Vehicle Safety Recall - Technical Service Bulletin

Attention: McNeilus Product Owner
Subject: 140" Frame Mount CNG with Luxfer Valves
Models Affected: Bridgemaster Rear Discharge Mixer and Standard Rear Discharge Mixer
Model Year: 2016 - 2018
Date: January 2019

PROCEDURE: Remove and replace Luxfer valves with another valve and specific fittings

Figure 2

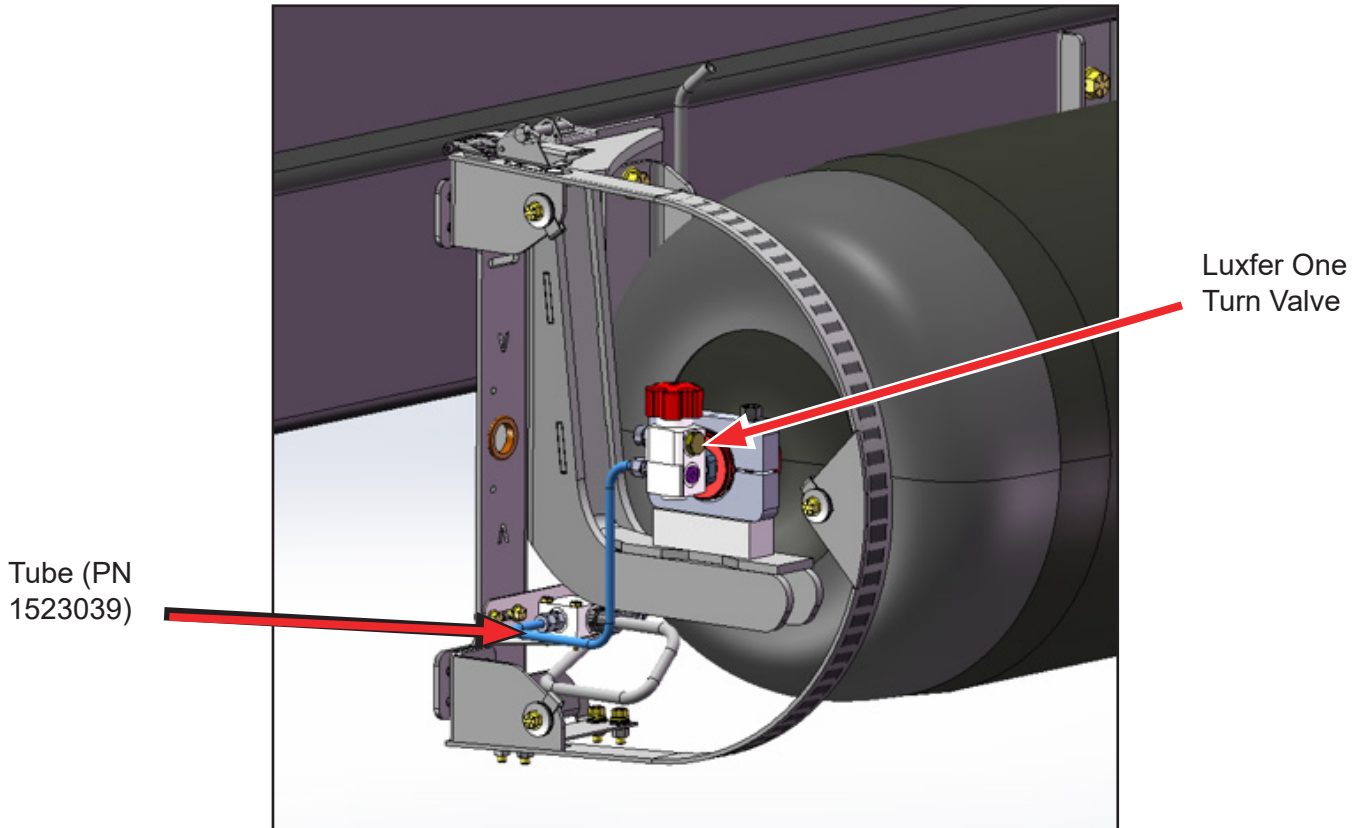
5. Refer to the illustration in Figure 2 to disconnect the tube (highlighted in blue) and remove the Luxfer valve from the CNG tank. Discard the Luxfer valve.

Figure 3

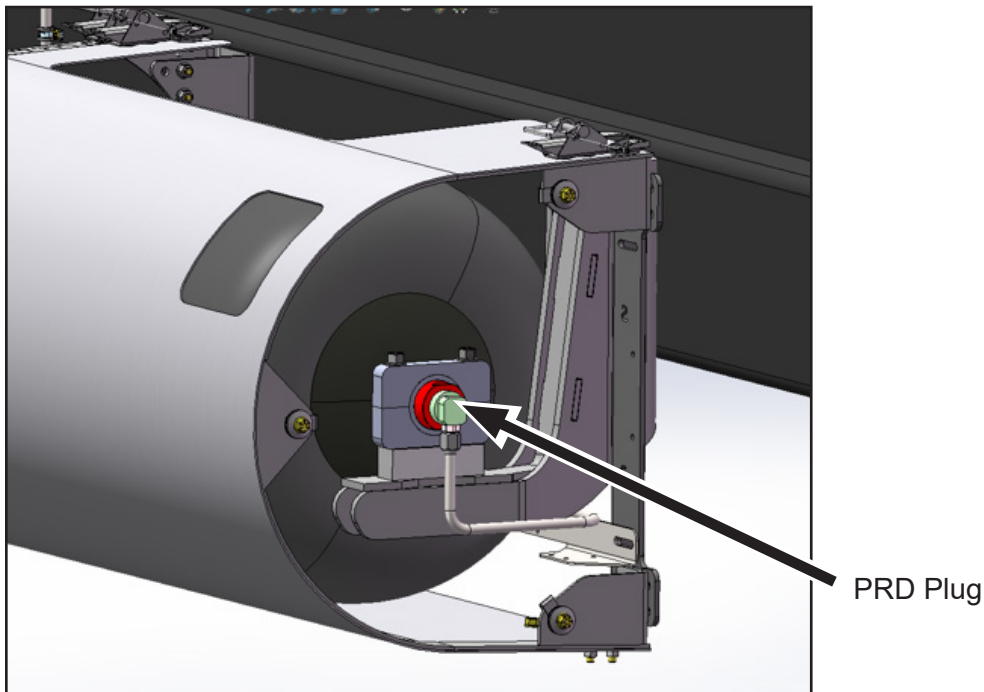
6. Disconnect PRD vent line and remove PRD plug (PN 1519024) (Figure 3).

Figure 4

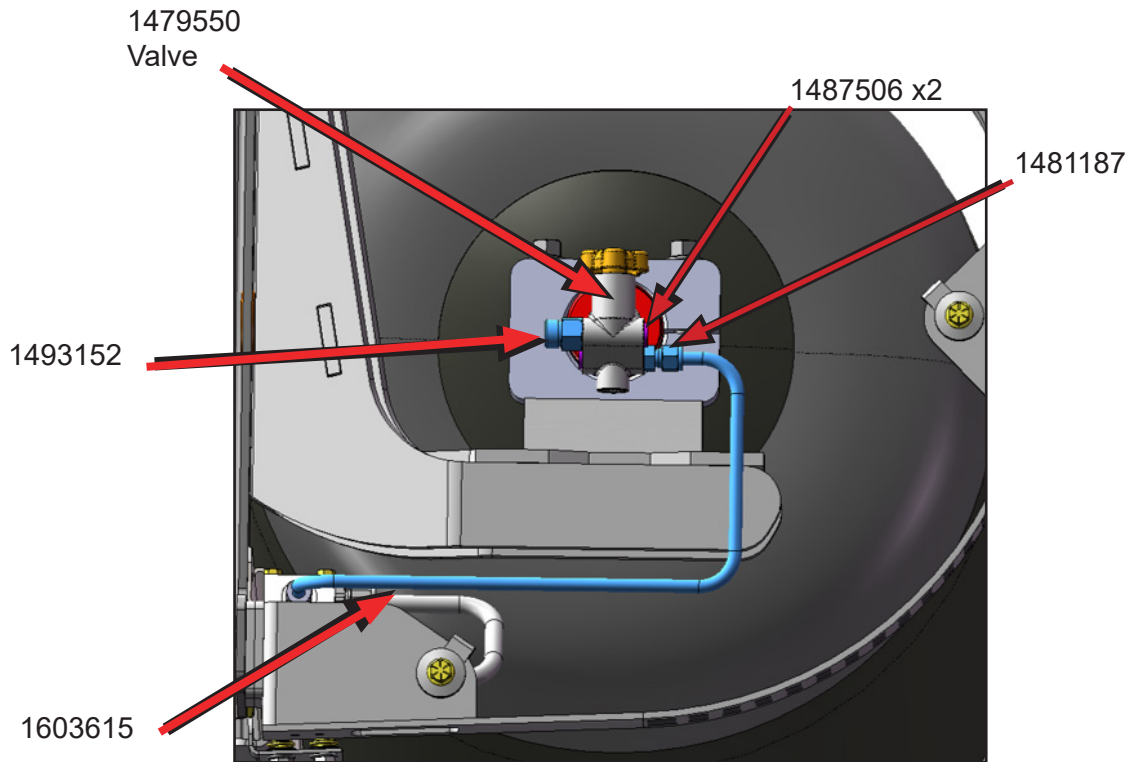
7. Install replacement fittings, plugs, tubes, and new OMB valve according to the illustration below (Figure 4).

8. Use a torque wrench to torque the fittings to 60 ft.-lbs and the valve to the tank to 80 ft.-lbs.

Figure 5

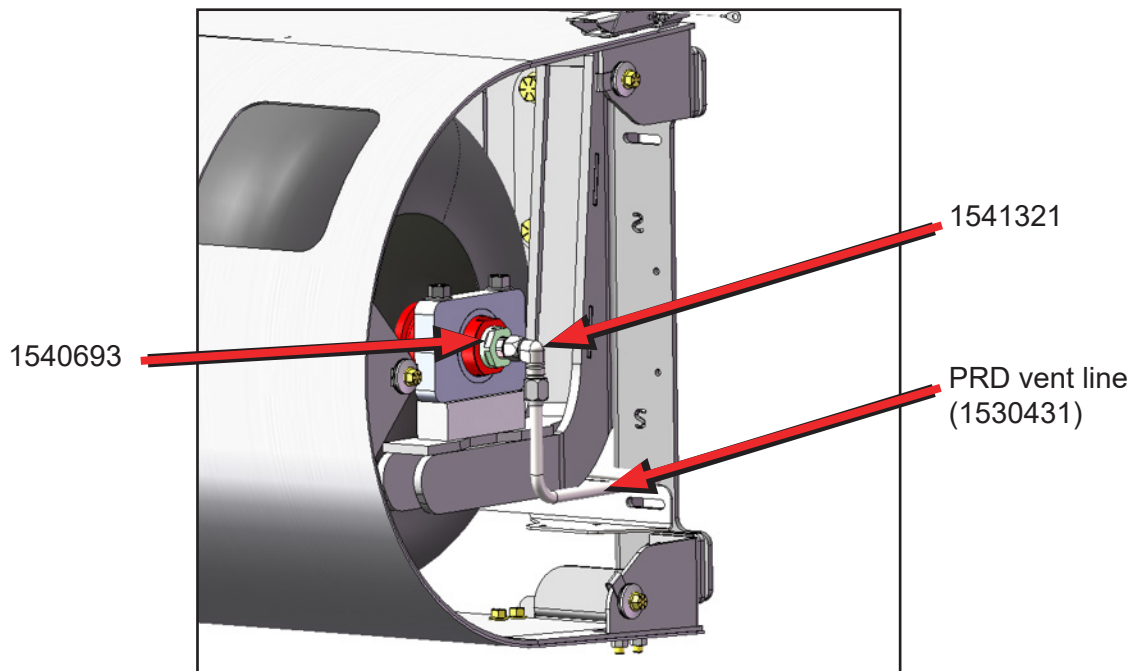
9. Install the new PRD plug (1540693) and 90-degree fitting (1541321) (Figure 5). Adjust the PRD vent line to connect to the 90-degree fitting.

10. Use a torque wrench to torque the fittings to 80 ft.-lbs.

Figure 6a

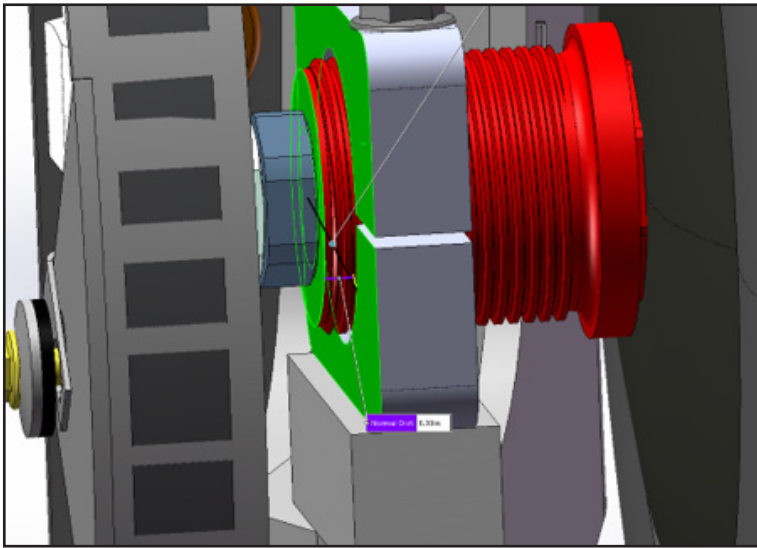
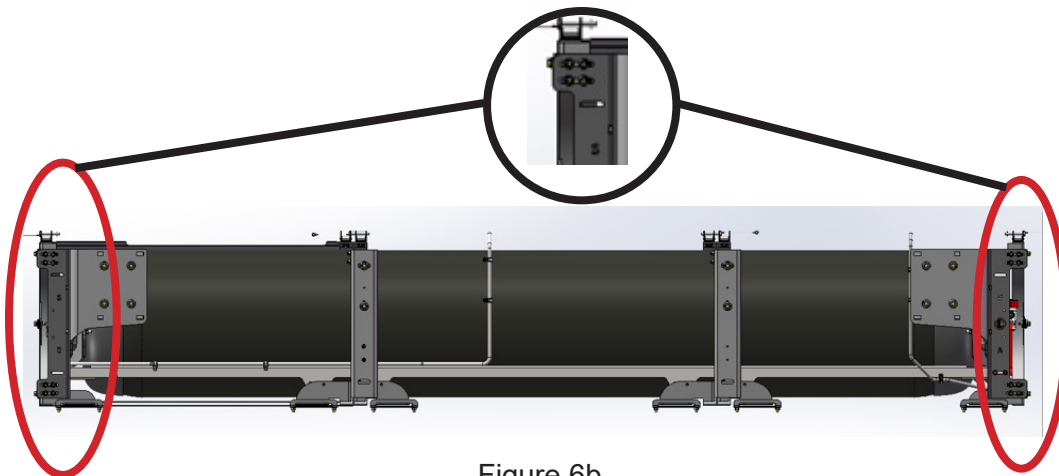
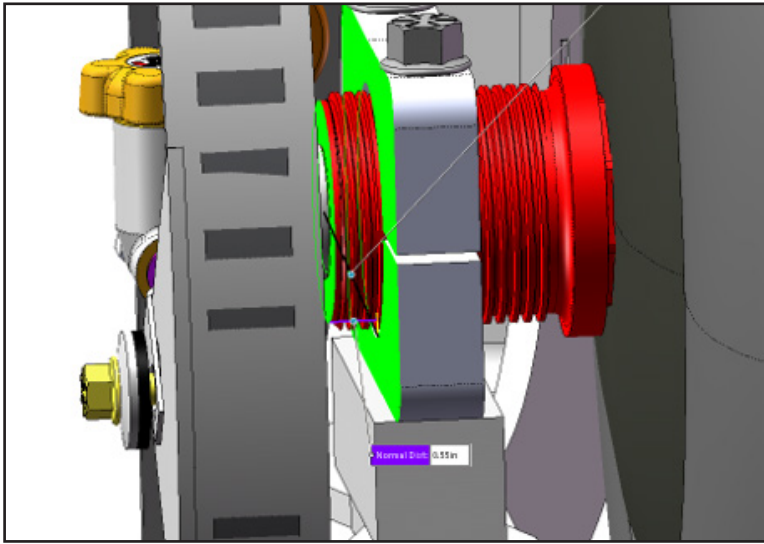
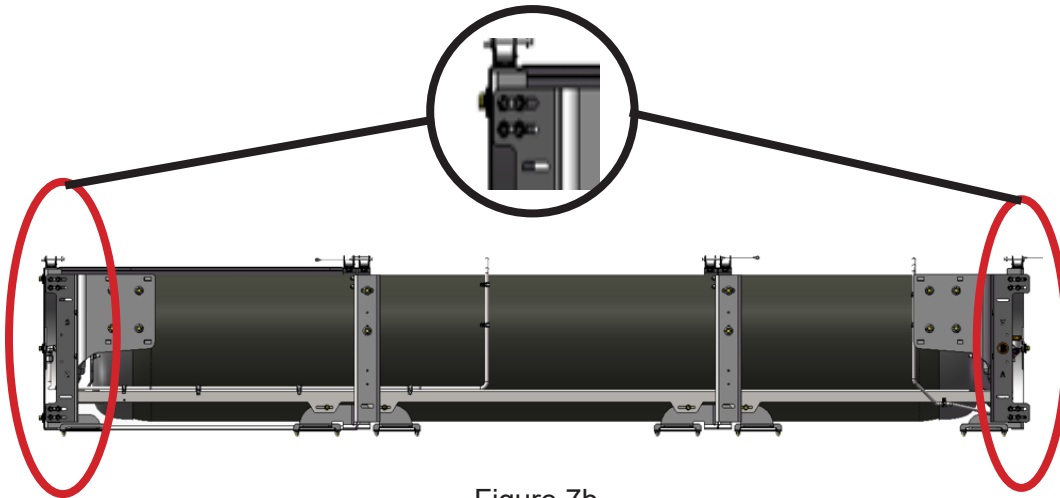
11. The new valve and PRD plug assemblies have the potential to cause interference with the CNG tank cover. If this occurs, the cover and tank must be adjusted. Follow steps 12 and 13 to make the adjustments. Adjustment may or may not be necessary based on layout from the factory.
12. The interference may require the tank to be adjusted toward the valve end in the fixed pillow block and the covers to be adjusted toward the floating end of the assembly (see illustrations below).
13. Reinstall the cover and hardware when ready to adjust. If no adjustment is necessary, reinstall the cover and hardware and continue at step 14.
 - Use a torque wrench to torque to 28 ft.-lbs.

The distance is 0.30" as shown in Figure 6a. Figure 6b. shows that before the adjustment, the cover mounts are centered in the slots.

The distance is 0.55" as shown in Figure 7a. Figure 7b. shows that after the adjustment, the cover mounts favor the floating end of the slots.
